SKEP III Home Office Support Site Visit Report

Consultant	Wahib Medanat Consultant Engineer	Rep No.	22-19042022
Contractor	Dijlah Establishment Constr. Contracting	Tender No.	(11/2019/USAID/SKEP/3/S) Schools for a Knowledge Economy Project (SKEP) - Phase (3) Package (1, 2)
Site Name	Thahr Al Sarow Basic School for Boys- Jerash	Day/ Date	Tue. 19/04/2022
Duration of Project	450 Calendar Days	Total Project Budget	8,314,983.735 JD

(Figure: 06, 07 & 08)

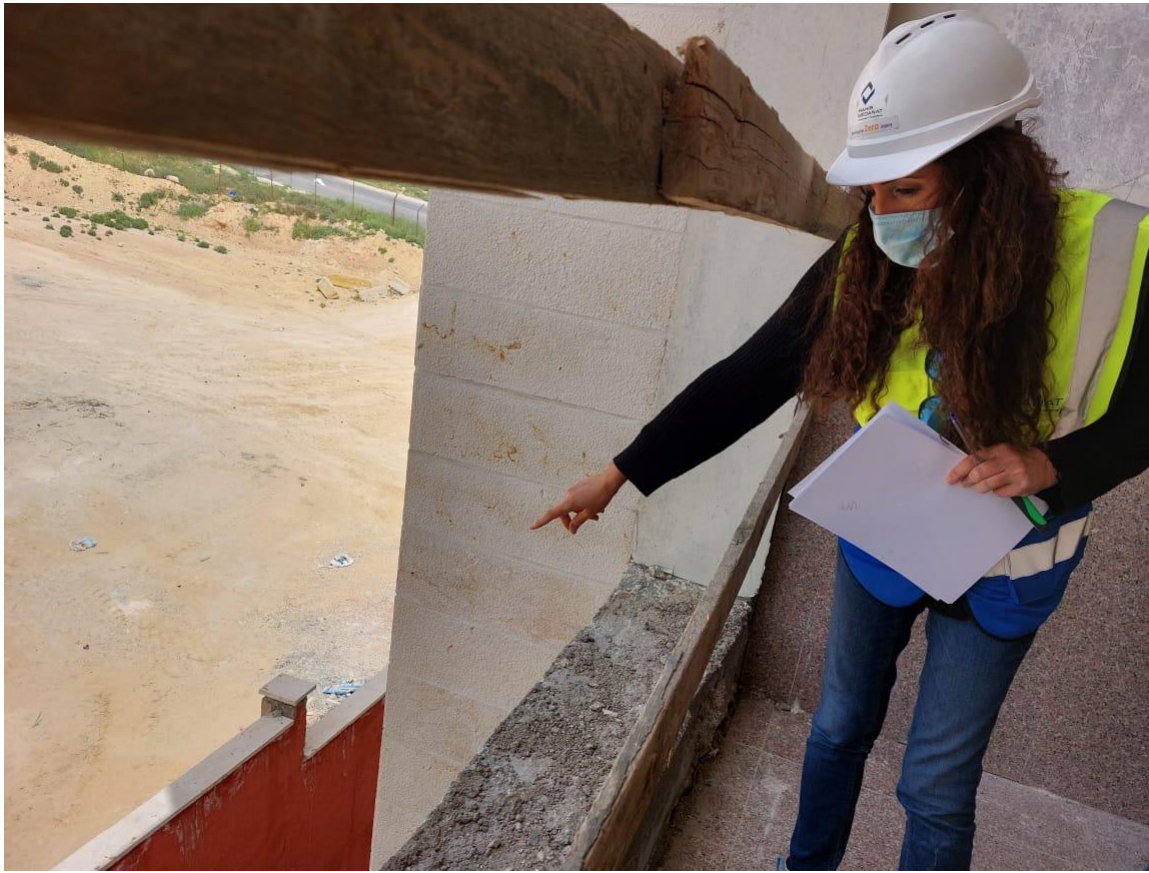
The team observed that parts of built stones at facades are still defective and not replaced
